**Re: Preliminary Site Plan Review Application; Conversion to Residential
Tax Map 1, Lot 32, 35 Badgers Island West
Response to CMA Comments**

On behalf of BIW Inc. we hereby submitted revised plans and supporting material for **Preliminary Site Plan Review Approval** to address the comments from the May 18, 2023, review letter from CMA Engineers. The review was of our April 6, 2023, submission. The Planning Board, at your April 27, 2023, meeting, voted to schedule a Public Hearing for the May 25, 2023, Planning Board. The comments were just received on May 18th. While we understand there is limited time to review our response prior to the meeting, we would like the opportunity to walk the Board through our response at the meeting. The specific comments, repeated below with our responses in bold text, are as follows:

EXISTING CONDITIONS PLAN

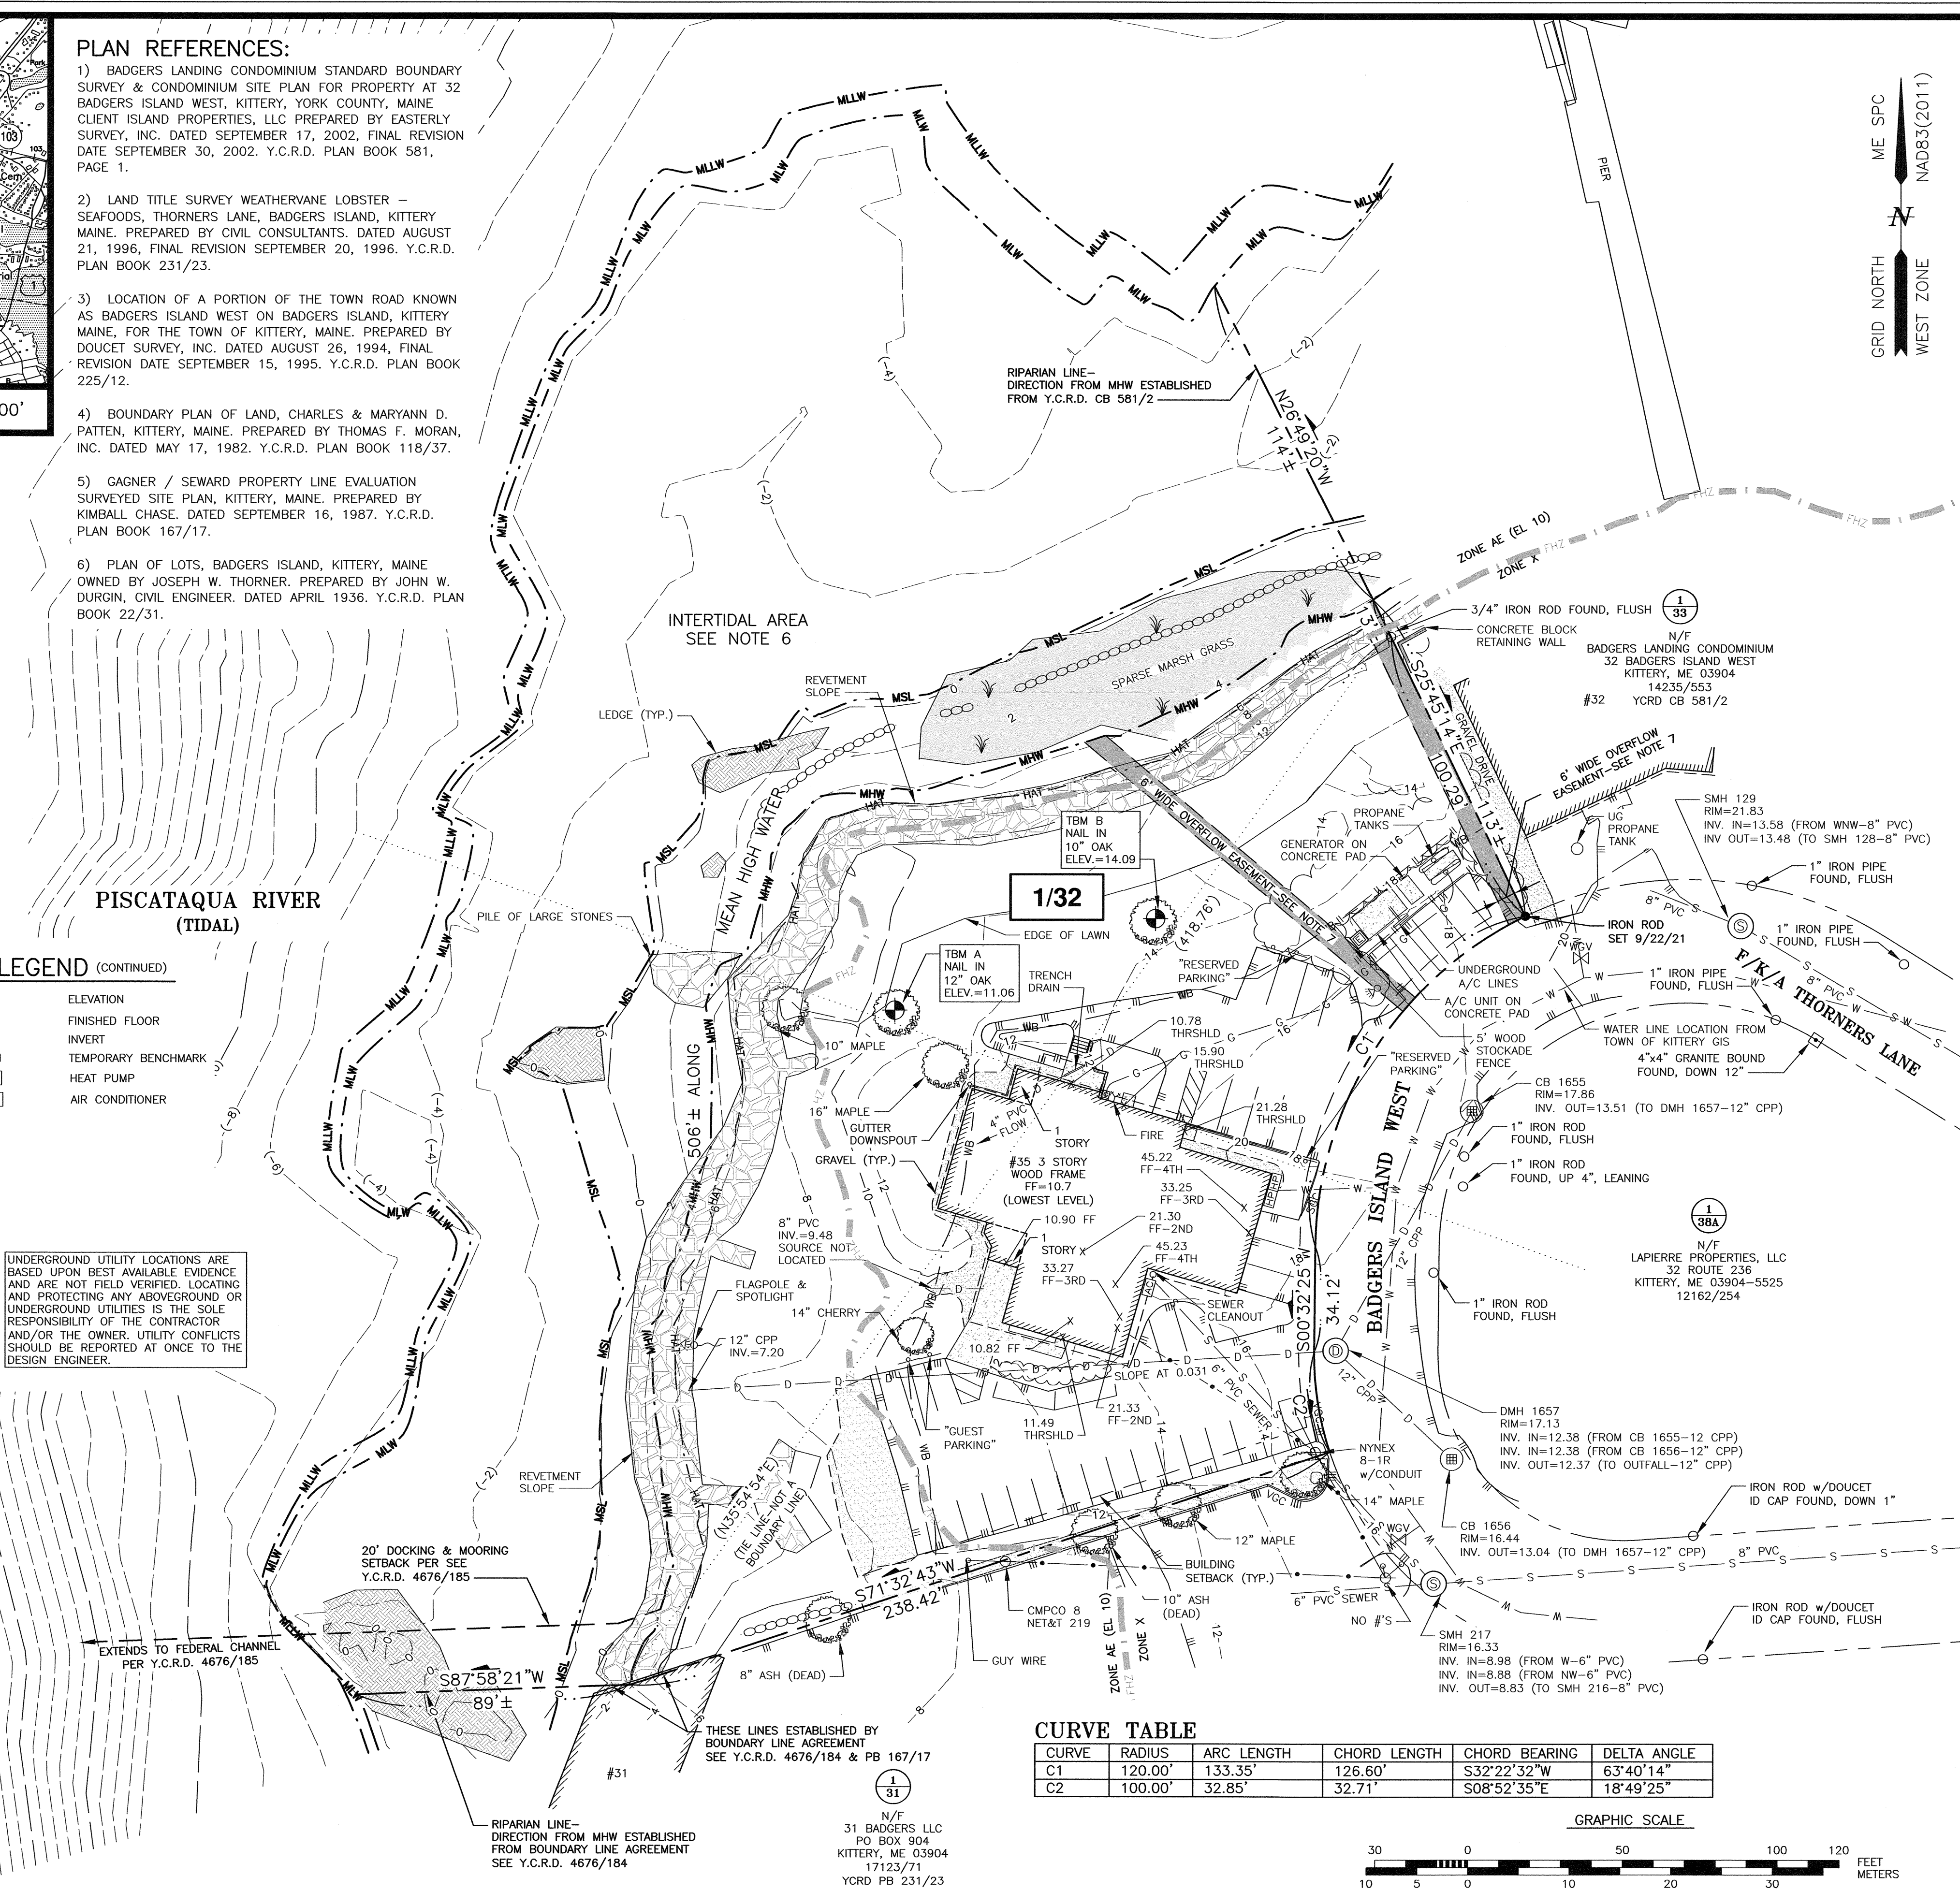
1. The legend should be updated to apply to the plans. **We have edited the Legend to be site specific.** Is the Devegetated Coverage Calculation necessary on this sheet? **We would like to leave it on as it provides added information about the existing site condition.**

① POROUS PATIO/WALKWAY DETAIL
NTS

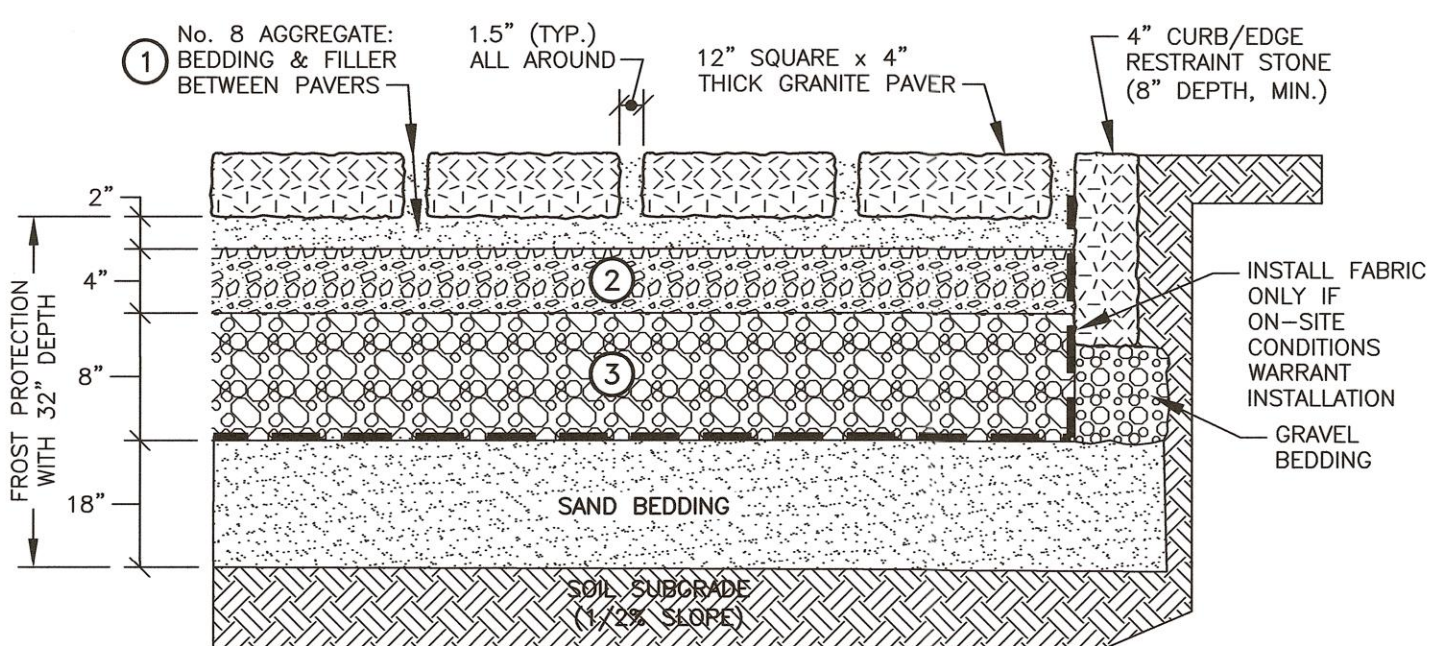
11. The site plans include a permeable paver patio and walkway. Have test pits and/or infiltration tests been completed on the existing soils to assess infiltration capacity? **The sites can be reviewed, and the information provided.** In addition, there are no details provided for the permeable pavers (select materials, piping, etc.) **Detail added to Sheet C2.**

SHORELAND DEVELOPMENT PLAN

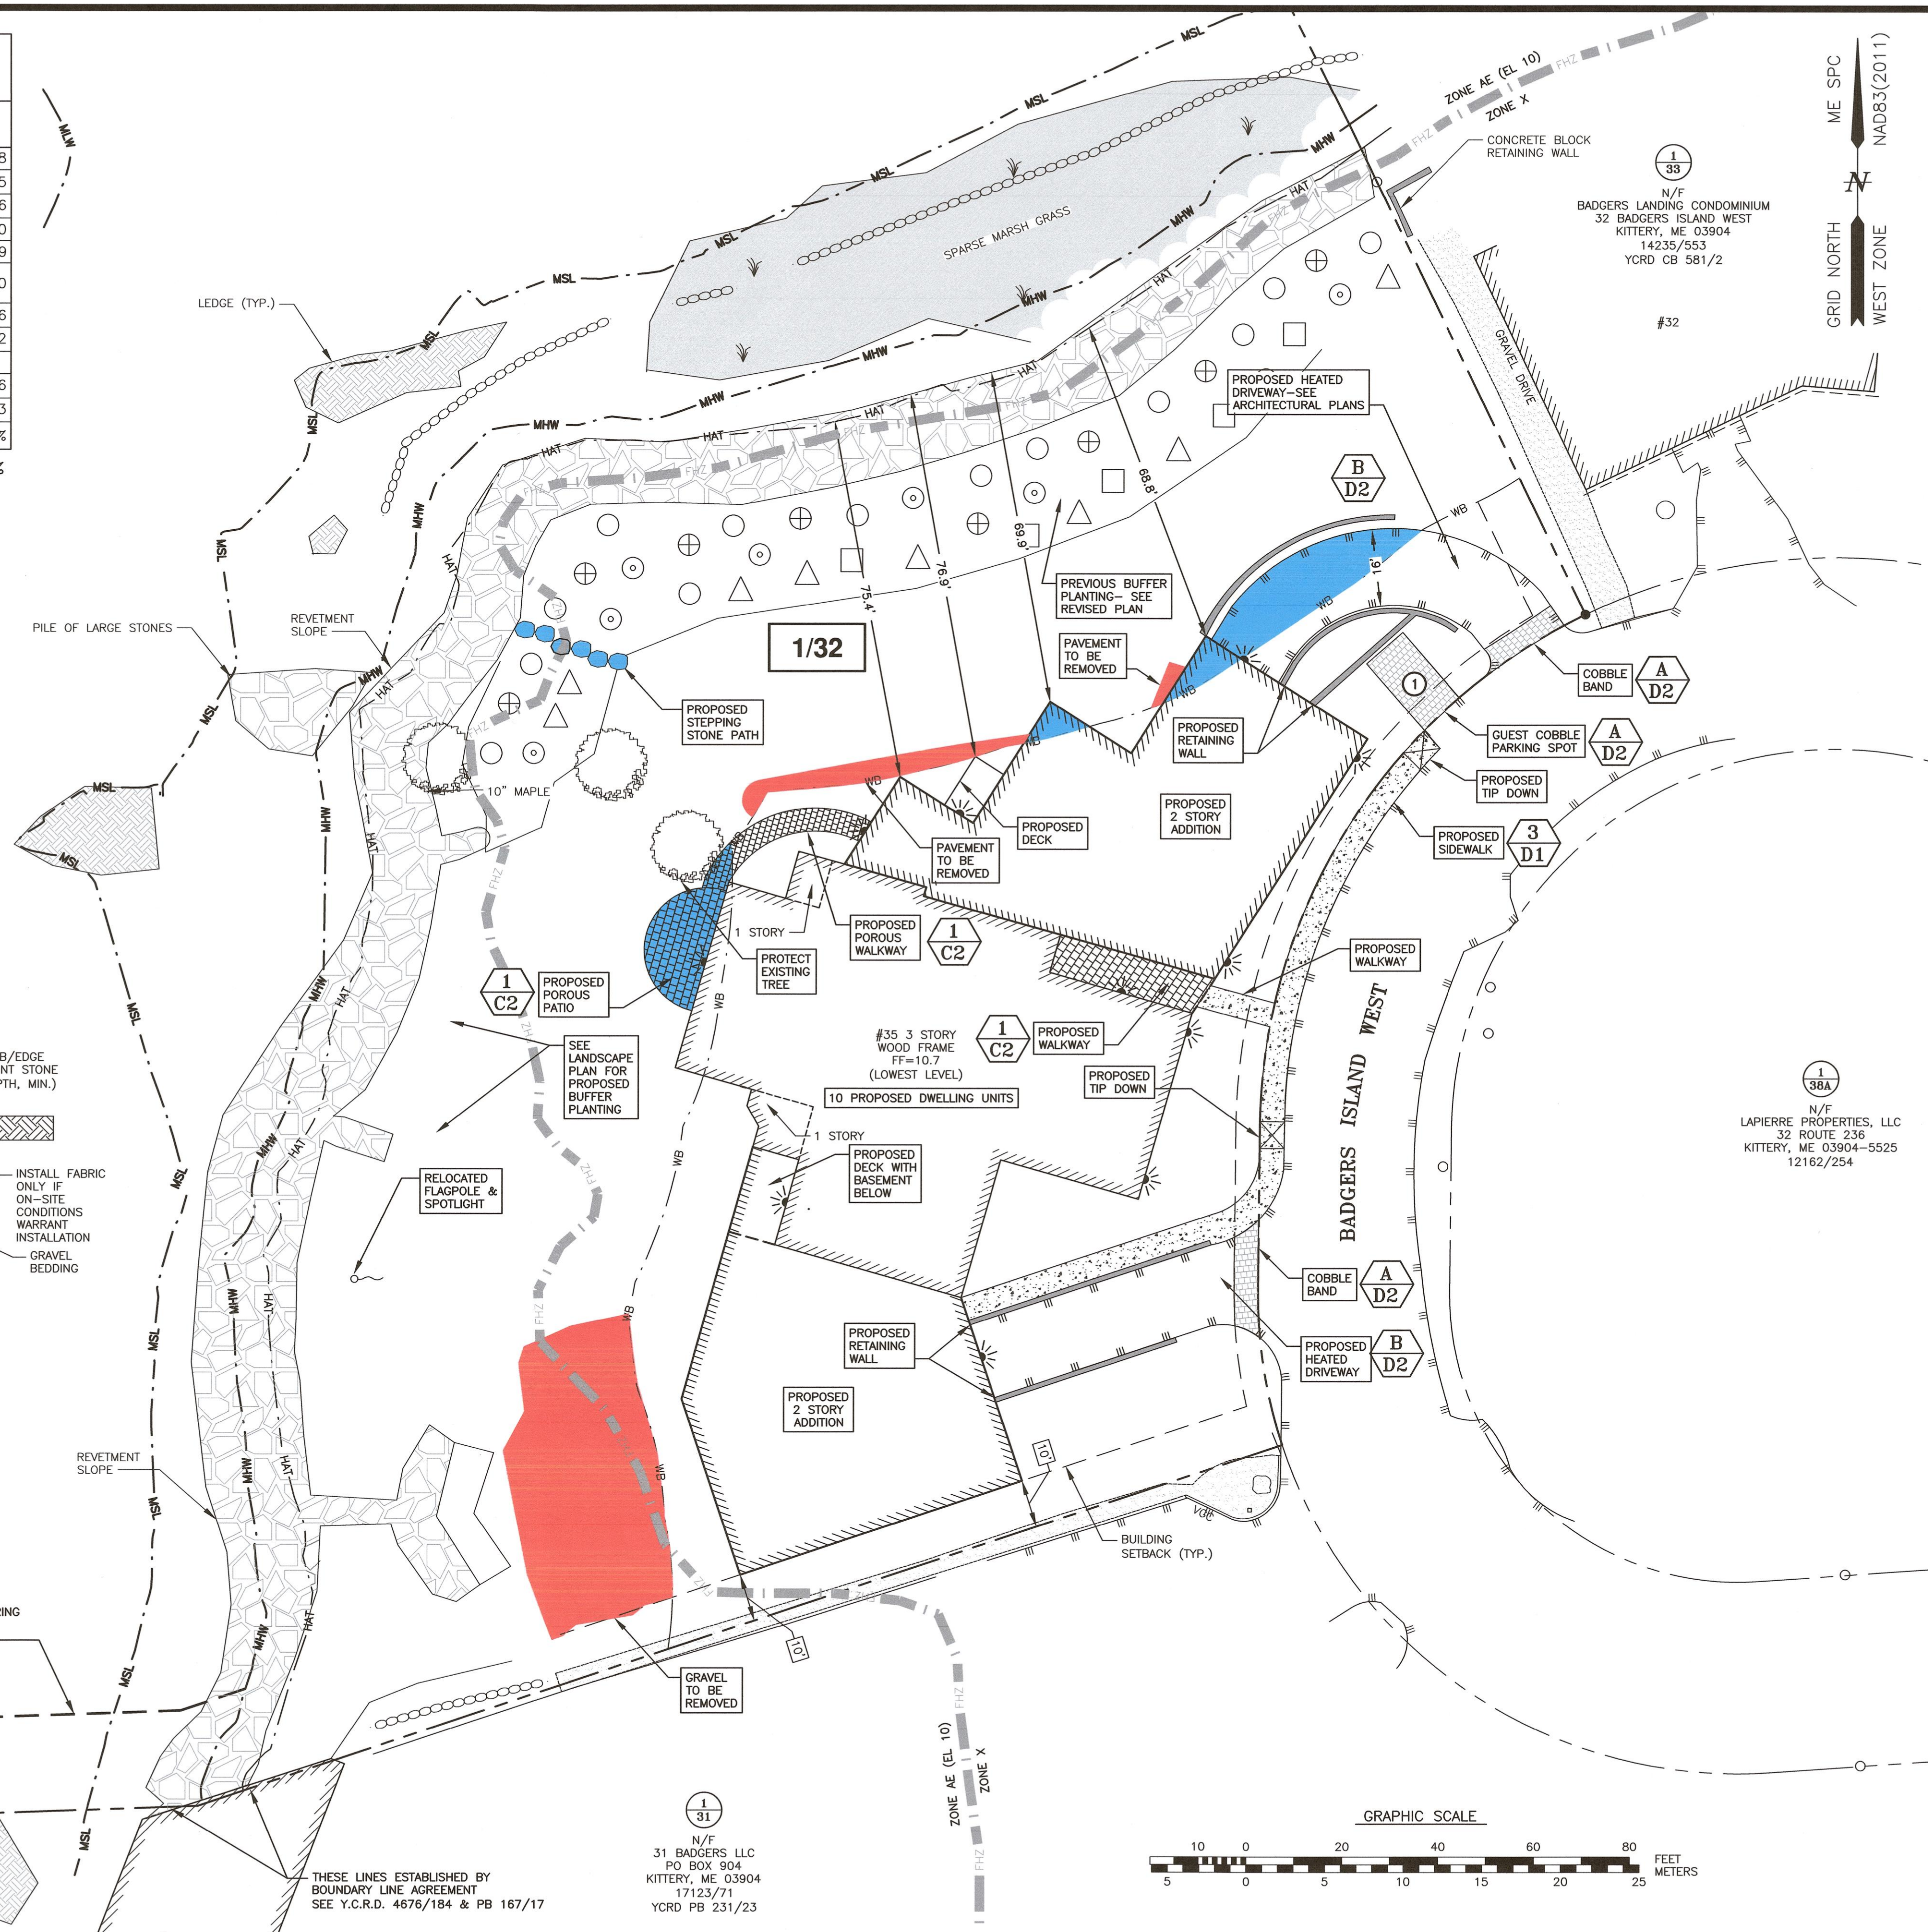
1. It is not clear why the proposed building and driveway need to encroach into the wetland buffer. **The project proposes minor intrusions into the wetland buffer and includes a reduction in the total buffer impact. The placement of the existing building on the property and the desire to revise the surface parking to underground parking create the need to impact the buffer to accomplish the project goals.**
